RYDE TOWN HALL

ACCESS AUDIT

MARCH 2024

The Goddard Partnership Ltd

EXTERNAL STEPS ON APPROACH ROUTE

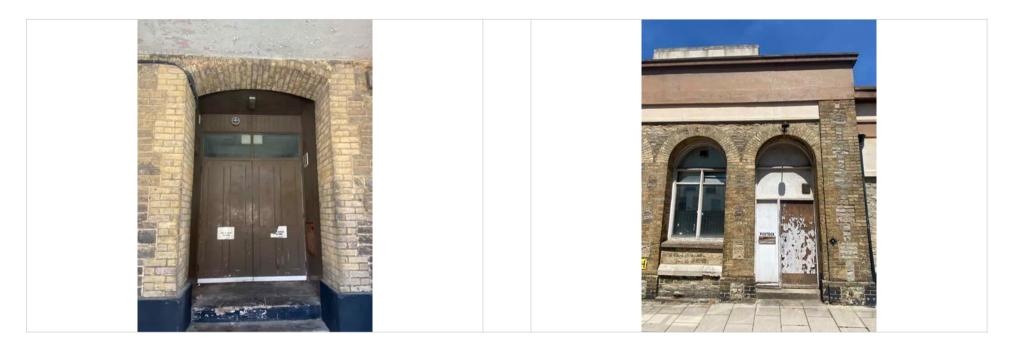
Area	The Current Situation	Recommendations for improving access

HANDRAIL TO INTERNAL STEPS

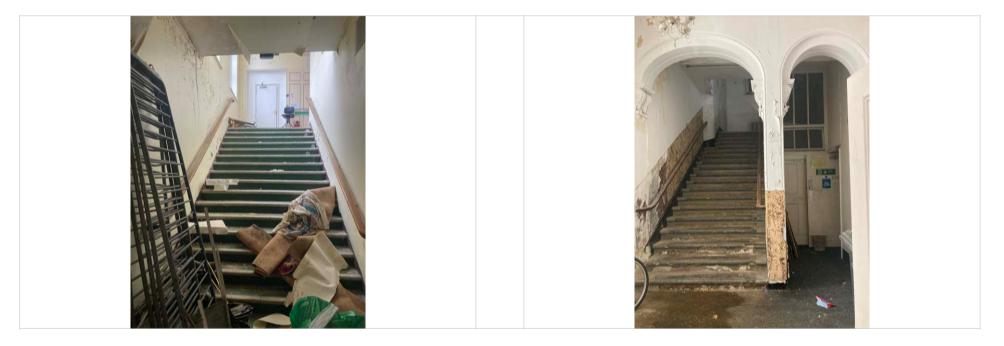
Area	The Current Situation	Recommendations for improving access
	Present to main staircases	Form part of historic fabric therefore any alterations will be limited

DESIGNATED PARKING BAYS AT MAIN ENTRANCE

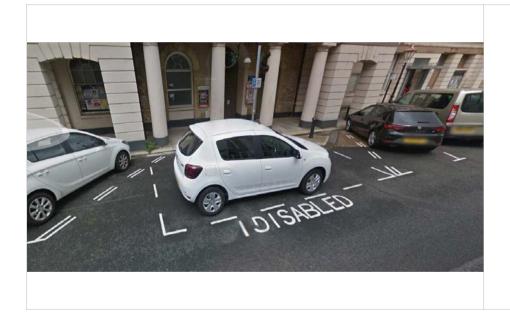
Area	The Current Situation	Recommendations for improving access
	Single parking bay only available	New parking arrangement to be determined for Lind and Market Streets

MAIN ENTRANCE

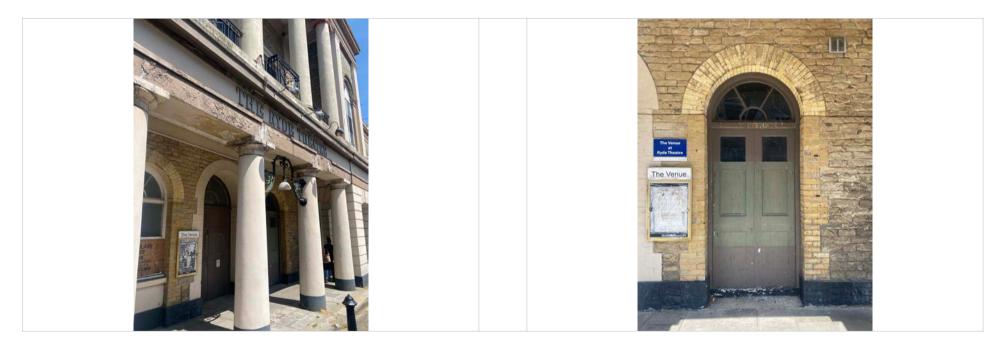
Area	The Current Situation	Recommendations for improving access
	There are a number of openings that could form the main entrance - the doorways behind the portico provide level access into the building.	Determine best locations for main and secondary entrances.

SIGNAGE AT MAIN ENTRANCE

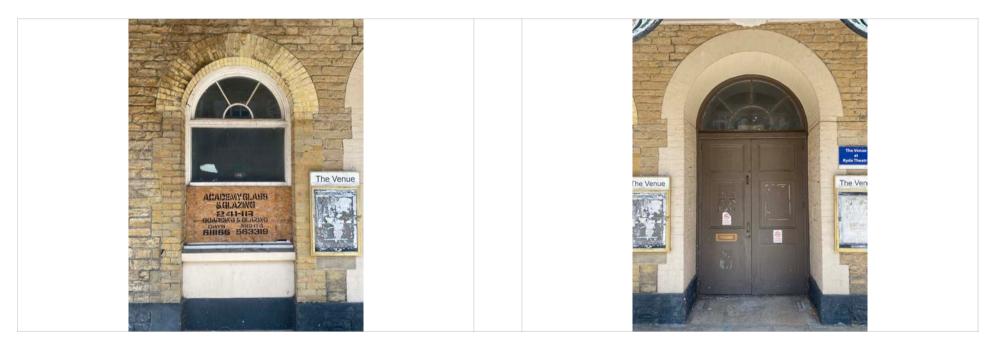
Area	The Current Situation	Recommendations for improving access
	Signage is inadequate	Determine signage requirements to comply with best practice as part of reuse scheme.

LOBBY AT MAIN ENTRANCE

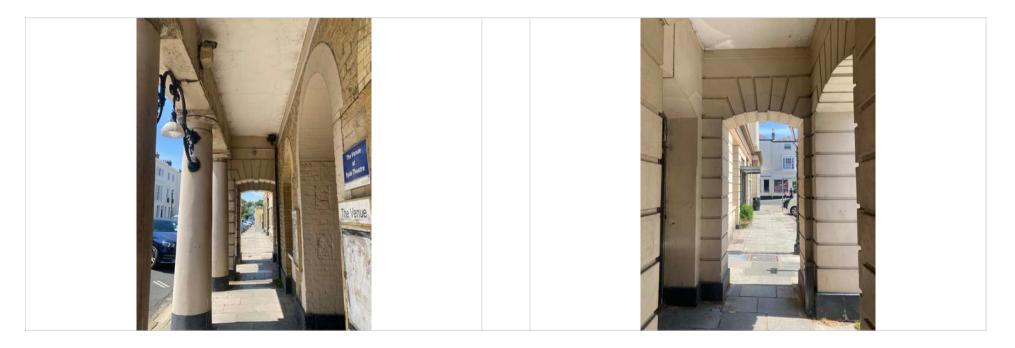
Area	The Current Situation	Recommendations for improving access
	Lobby is spacious and largely protected from rain/inclement weather	Ensure safe and level access is available

INNER FOYER

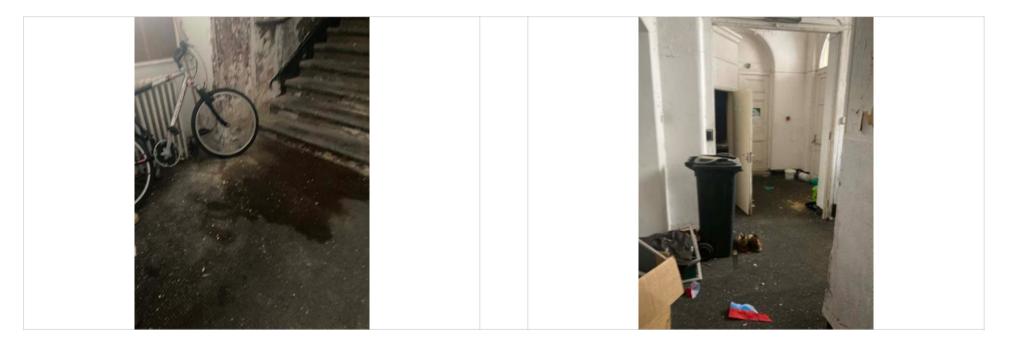
Area	The Current Situation	Recommendations for improving access
	Space limited by rubbish and modern kiosk	Remove rubbish and modern additions - ensure compliance with legislation in reuse scheme.

INTERNAL STAIRS

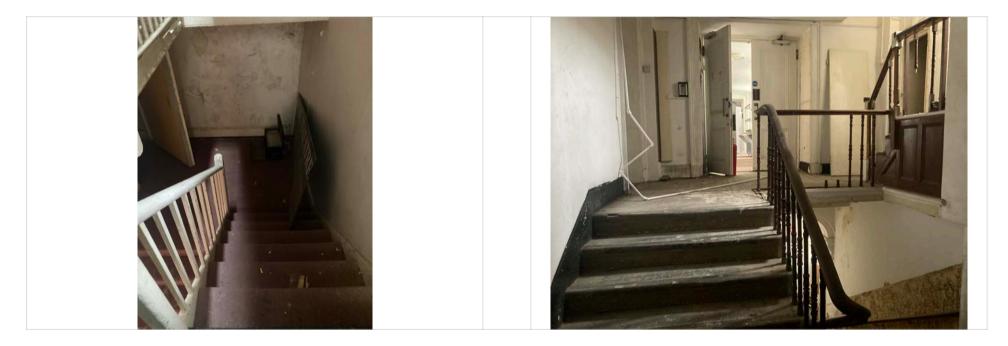
Area	The Current Situation	Recommendations for improving access
	Timber stairs in places are narrow and may be challenging as a means of access.	Larger and more regular staircases are available that may serve better as principal access routes through the building.

INTERNAL ACCOMMODATION

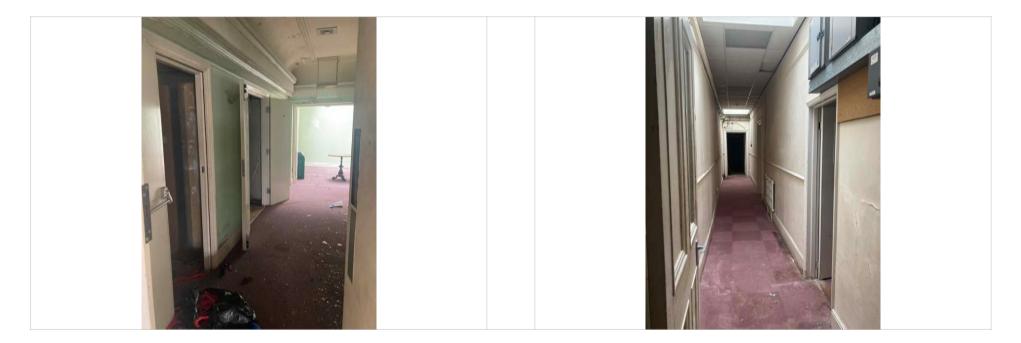
Area	The Current Situation	Recommendations for improving access
	Modern fit out compromises access in places	Listed status of the building must be considered in determining future layout, however removal of modern insertions will open up many of the spaces within the building which will allow for a new scheme to remove many of the impediments presently restricting access.

TOILET FACILITIES

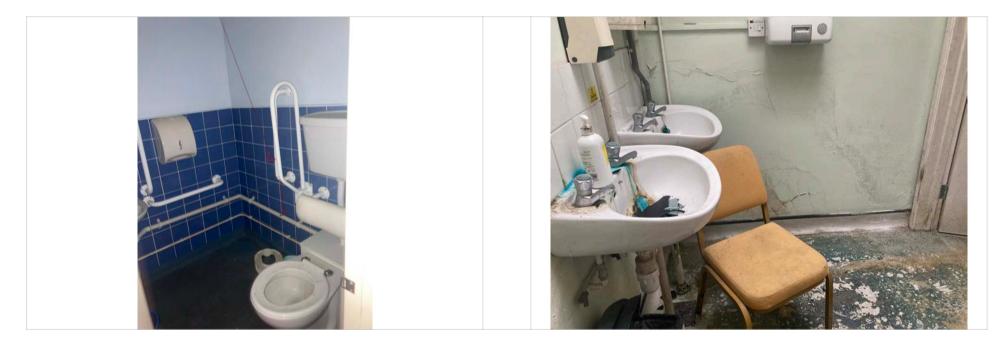
Area	The Current Situation	Recommendations for improving access
	Sanitary facilities are redundant are require removal	New scheme to provide compliant and accessible facilities
